SERVICE BULLETIN NO: 32-016

ATA CHAPTER: 32

LANDING GEAR LANDING GEAR - INSPECTION AND REPLACEMENT OF COMPONENTS

NLG - Replacement of Components
Figure 1 (Sheet 1 of 2)

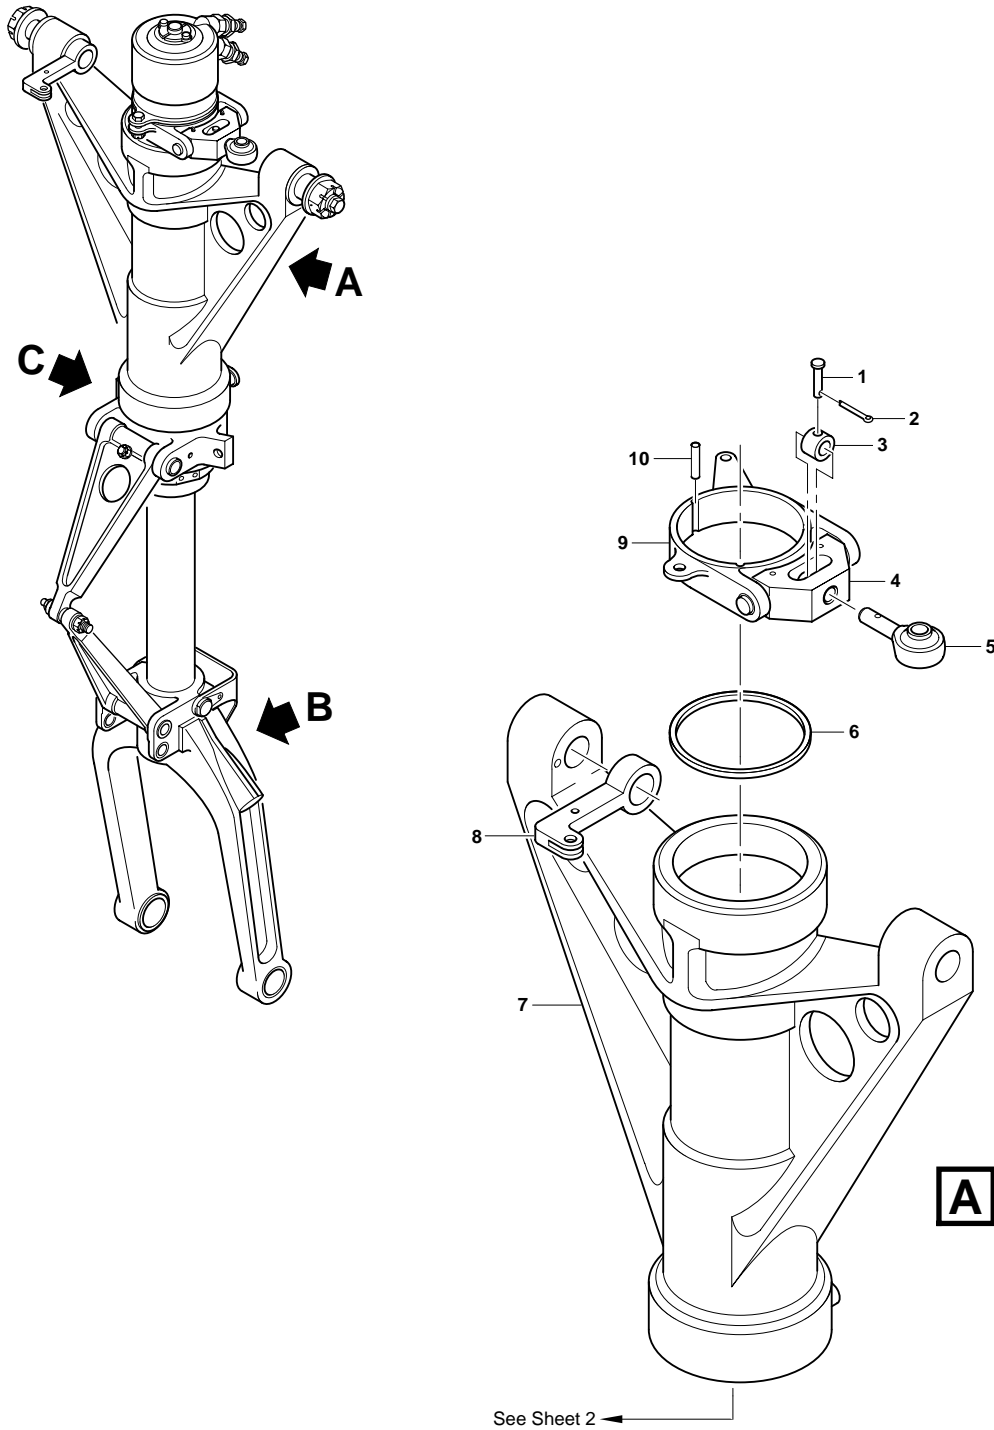
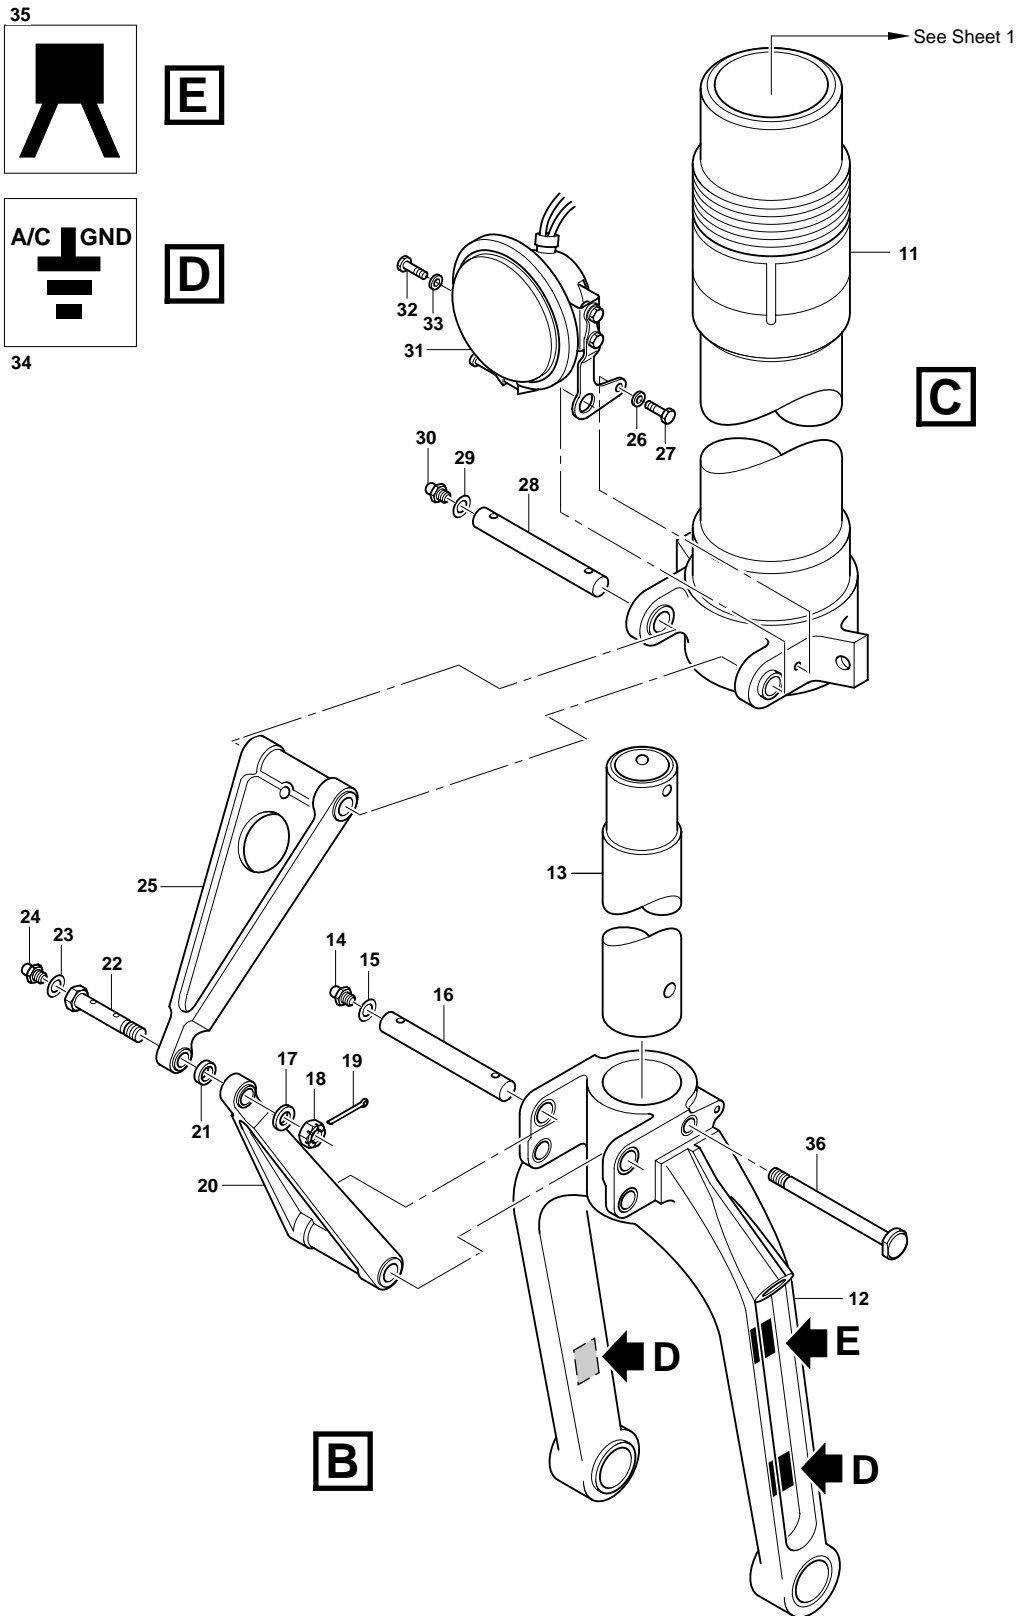
4. Accomplishment Instructions - Aircraft - Part B - NLG (Ref. Fig. 1)

- (1) Do the steps in section 2. Disassembly/Procedure (Ref. AMM, 32-20-00, Page Block 801). During the disassembly you must hold the steering tube (11) in position.
- (2) Send the removed bolt (36) to PILATUS.
- (3) Remove the taxi light.
 - (a) Remove and discard the locking wire from the bolts (27) and (32).
 - (b) Hold the taxi light (31) in position.
 - (c) Remove the bolts (27) and (32), and washers (26) and (33).

- (a) Remove the drive lever assembly (9) with the washer (6).
 - (b) Remove the three cylindrical pins (10).
 - (c) Remove the steering tube (11).
 - (d) Send the removed steering tube (11) to PILATUS.

- (2) Use a bearing press (or equivalent) to remove the cylinder pipe (13) from its bore in the nose wheel fork (12).
- (3) Send the removed cylinder pipe (13) to PILATUS.

- (6) Quickly push the cylinder pipe (13) in the bore of the nose wheel fork (12) and install the new bolt (36). Make sure that the holes for the new bolt (36) are correctly aligned before the temperature changes and you install the new bolt (36). Remove the new bolt (36).

- (4) Use the freezer or an approved alternative (approved alternatives are liquid nitrogen in an insulated box or dry ice) to decrease the temperature of the new cylinder pipe (13) to less than minus 75°C.

- (5) Use an oven or approved alternative (approved alternatives are an electrical blanket or hot air) to increase the temperature of the nose wheel fork (12) to 100°C.

- Torque the new bolt (36) to between 87 and 221 lbf ins (10 and 25 Nm).

MLG - Replacement of Components
Figure 2

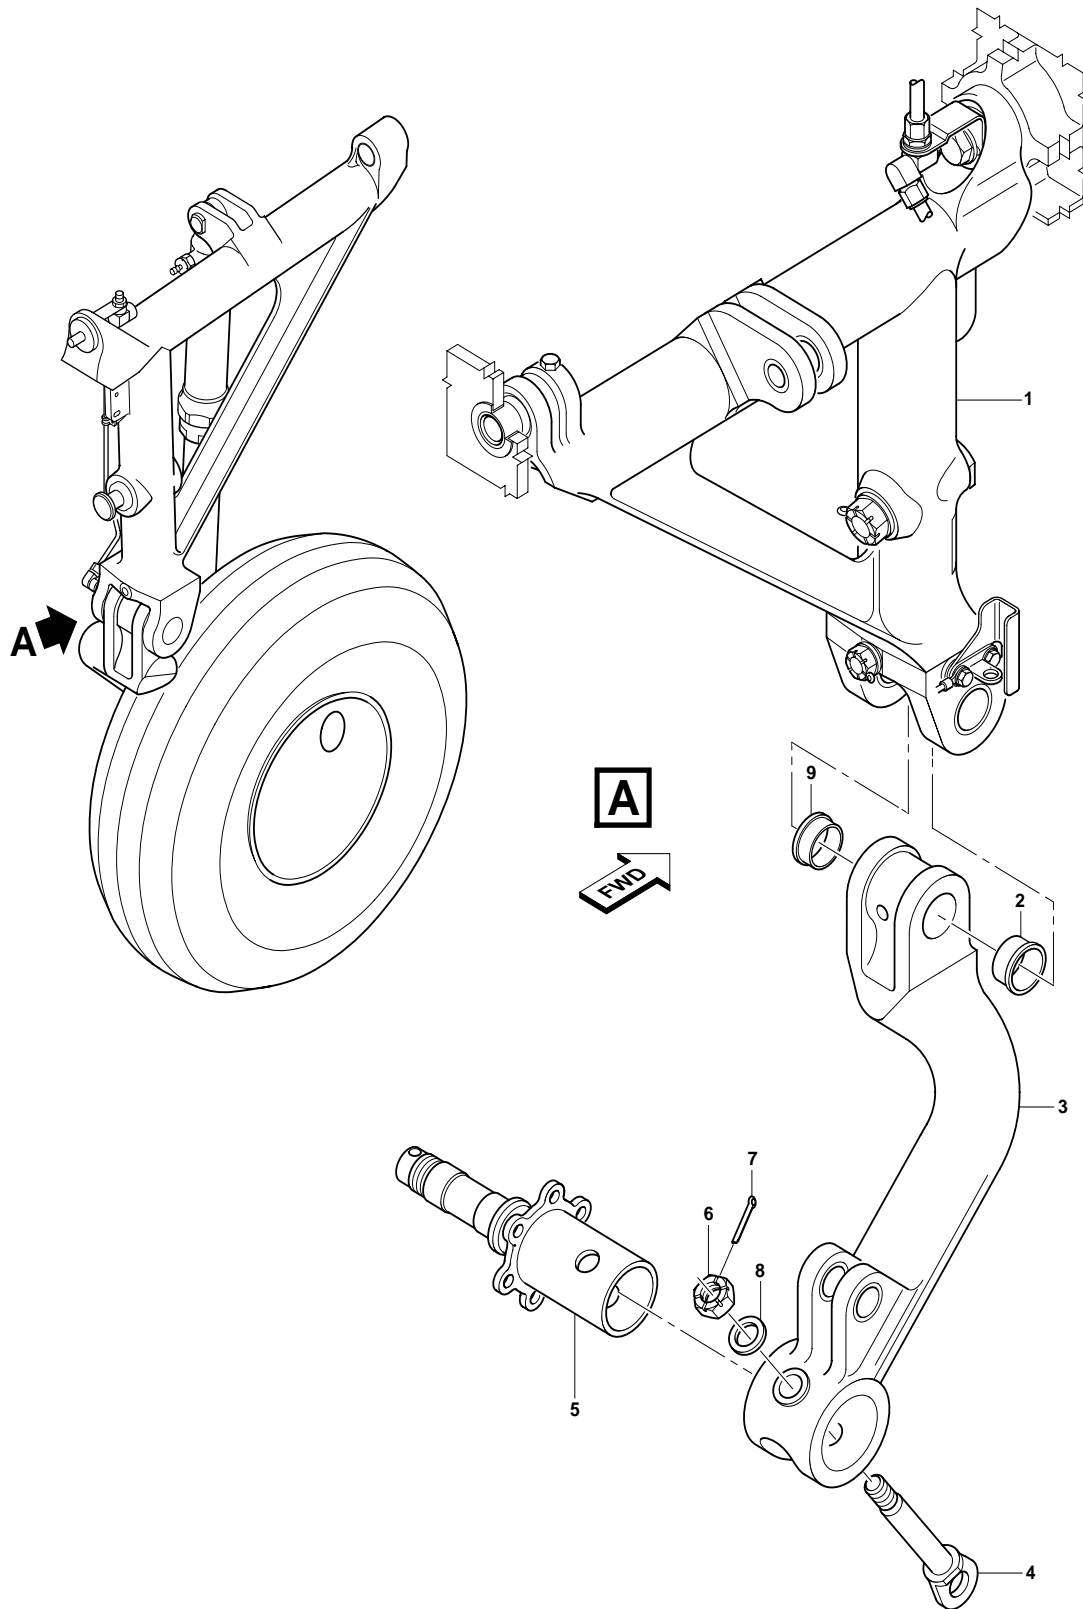
5. Accomplishment Instructions - Aircraft - Part C (MLG) (Ref. Fig. 2)

- (a) Use a hot air blower (or equivalent) to loosen the adhesive bond between the two bushes (2) and (9), and the surfaces in the bores in the trailing link (3).
- (b) Use a bearing press (or equivalent) or drift to remove the bushes (2) and (9).

- (2) Remove the axle from the trailing link.
 - (a) Obey the manufacturers instructions and use a cloth made moist with the solvent (Material Item No. P10-008 or approved alternative) and a scraper to remove the sealant. Do this from around the inboard end of the axle (5) and where the axle comes out of the trailing link (3).
 - (b) Remove and discard the cotter pin (7).
 - (c) Remove the nut (6), washer (8) and towing bolt (4).
 - (d) Send the towing bolt (4) to PILATUS.
 - (e) Use a bearing press (or equivalent) to remove the axle (5) from its bore in the trailing link (3).
 - (f) Send the axle (5) to PILATUS.

- (1) Install the new axle in the trailing link.
 - (a) Use the freezer or an approved alternative (approved alternatives are liquid nitrogen in an insulated box or dry ice) to decrease the temperature of the axle (5) to -75°C .

- (b) Use the oven or approved alternative (approved alternatives are an electrical blanket or hot air) to increase the temperature of the trailing link (3) to 100°C .

- (c) Quickly push the axle (5) in the bore of the trailing link (3). Make sure that the holes for the towing bolt (4) are aligned and install the new towing bolt (4).

- (f) Install the washer (8) and nut (6).
 - (g) Torque the nut (6) to between 290 and 410 lbf ins (33 and 46 Nm).
 - (h) Install the new cotter pin (7).

MLG Shock Absorber - Replacement of Components
Figure 3

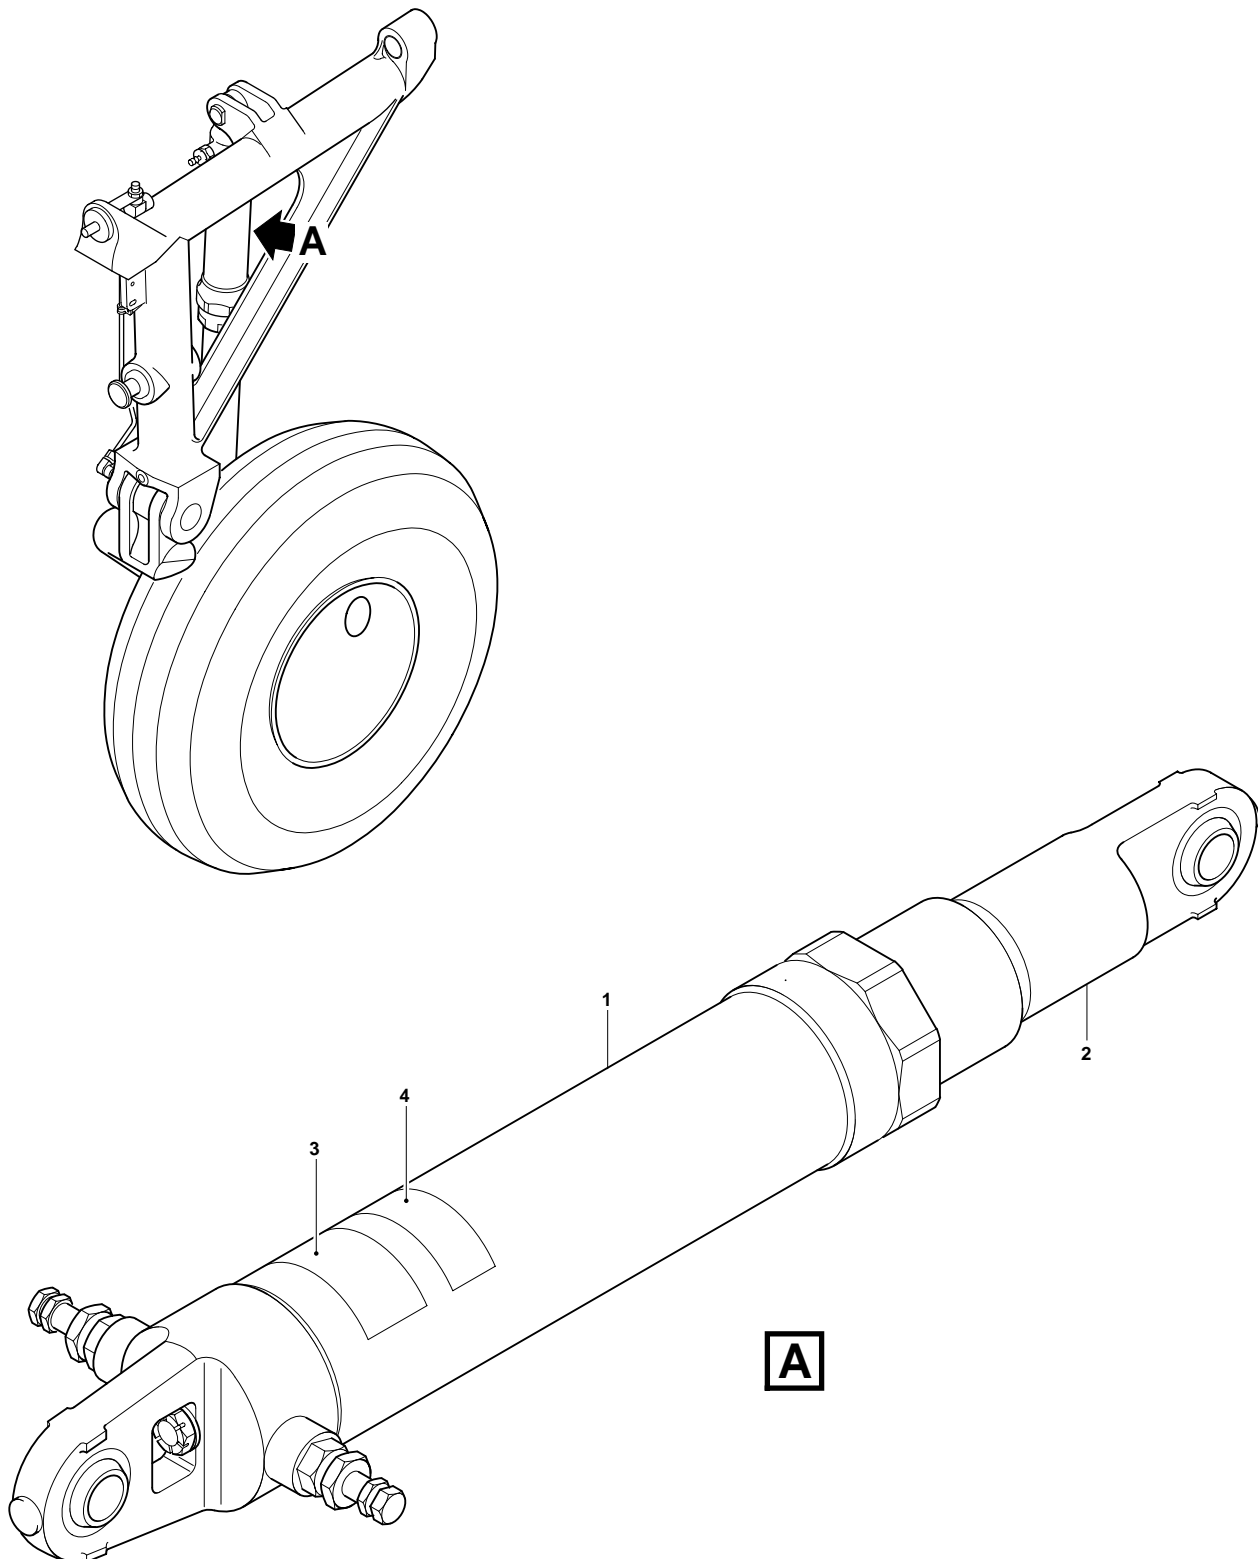
6. Accomplishment Instructions - Aircraft Part D - MLG Shock Absorber (Ref. Fig. 3)

- (1) Disassemble the MLG shock absorber (Ref. AMM, 32-10-00, Page Block 801).
- (2) Send the cylinder (2) and cylinder sleeve (1) to PILATUS.

- (1) Assemble the MLG shock absorber (Ref. AMM, 32-10-00, Page Block 801). Use the new seal kit (532.10.12.500).
- (2) Obey the manufacturers instructions and install the new placards (3) and (4) at the locations shown on the cylinder sleeve (1).
- (3) Use letter stamps to make a copy of the data recorded in Para A, Step (6) on the new placard (3). Record the date of assembly in the date box of the placard.
- (4) Install the shock absorber (Ref. AMM, 32-10-03, Page Block 401).
